ADDENDUM

PROJECT: University of South Dakota
Pardee Lab - SEM
Vermillion, South Dakota

AD-2

DATE ISSUED: Monday, November 10, 2014

Mechanical Plan

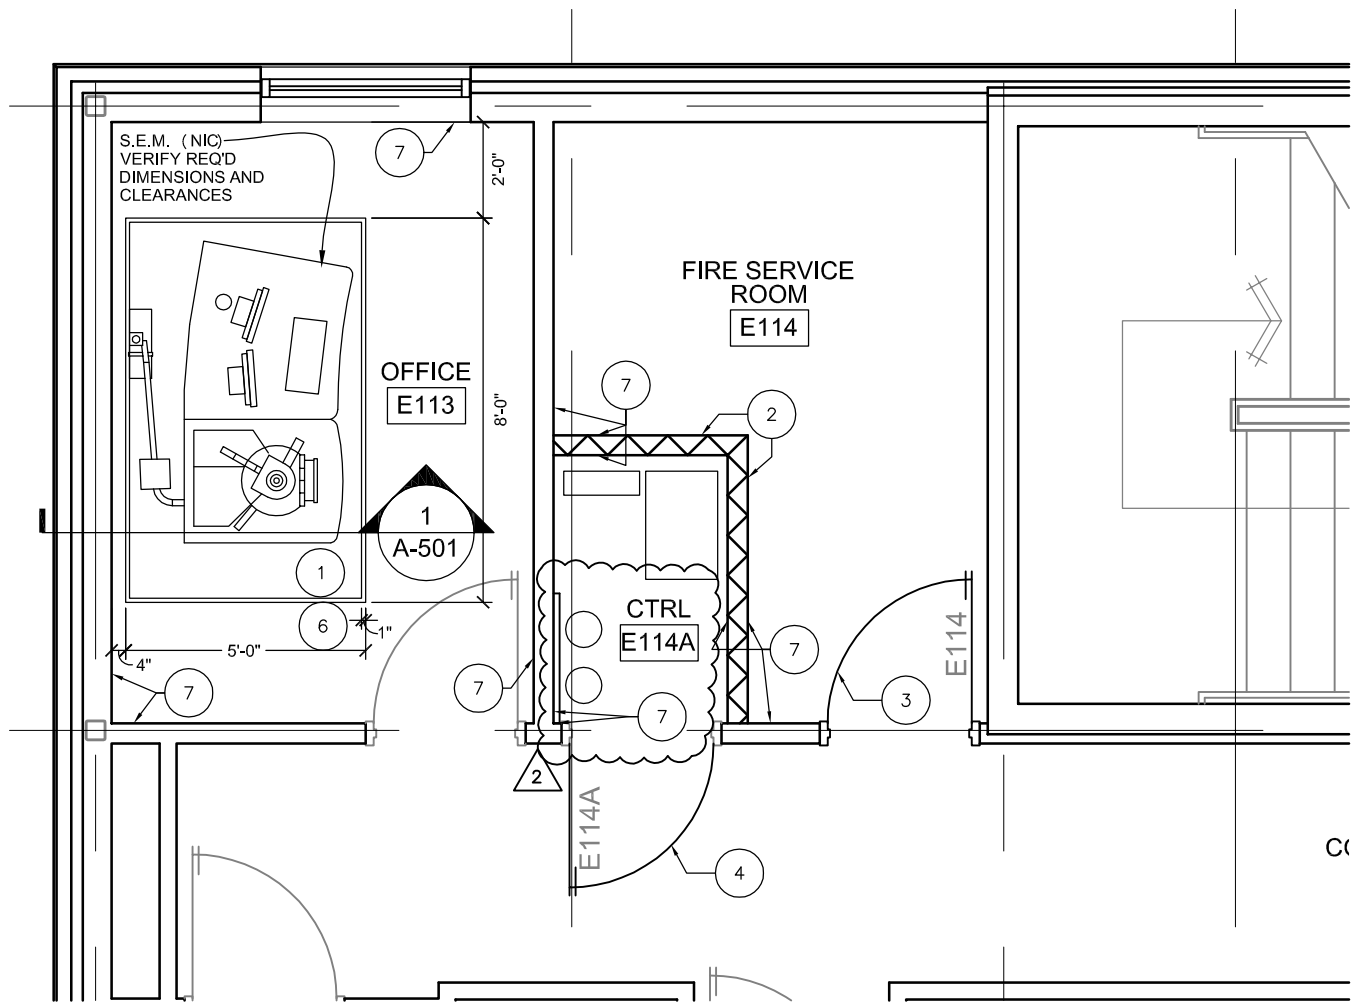
In reference to Sheet M-102, see attached Supplemental Drawing M-102.2 for additional nitrogen and vacuum piping.

- 12 PROVIDE CONNECTION POINTS FOR 2 CYLINDERS AT THIS LOCATION. PROVIDE ISOLATION VALVE, PRESSURE REDUCING VALVE AND PIG TAIL WITH CONNECTOR.
- 13 EXTEND 1" VACUUM PIPING FROM PUMP TO BACK OF MICROSCOPE. VERIFY EXACT LOCATION WITH THE CONTRACTOR.

Partial Floor Plan

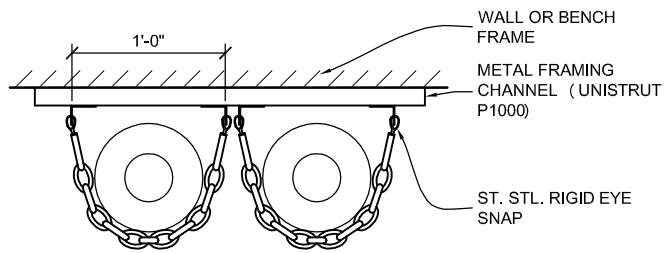
In reference to Sheet A-102, Detail 1, change to Detail 1 as shown on attached Supplemental Drawing A-102.2.

GAS CYLINDER RESTRAINT

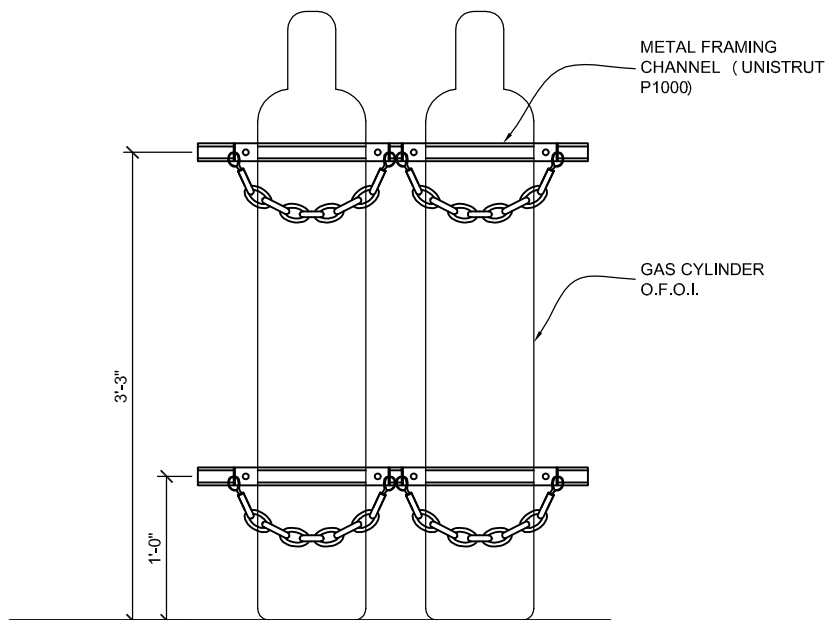
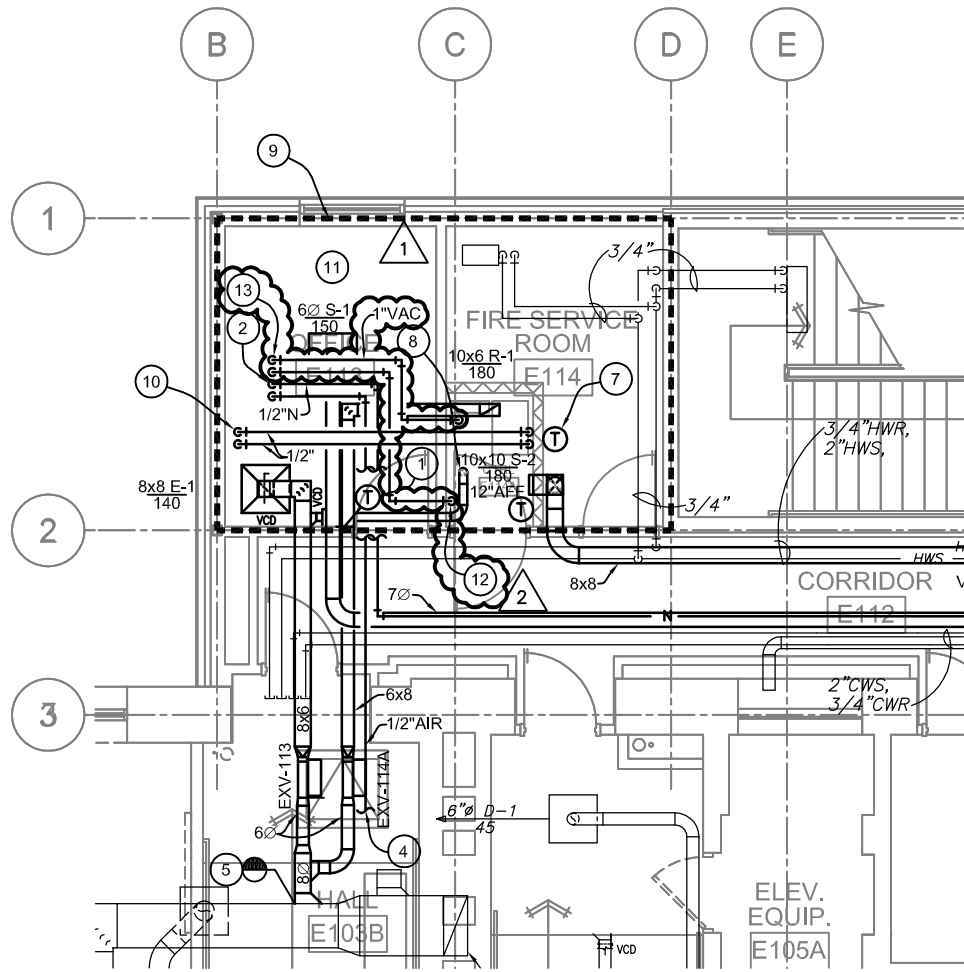
In reference to Sheet A-102, see attached Supplemental Drawing A-102.3 for gas cylinder restraint plan and elevation.
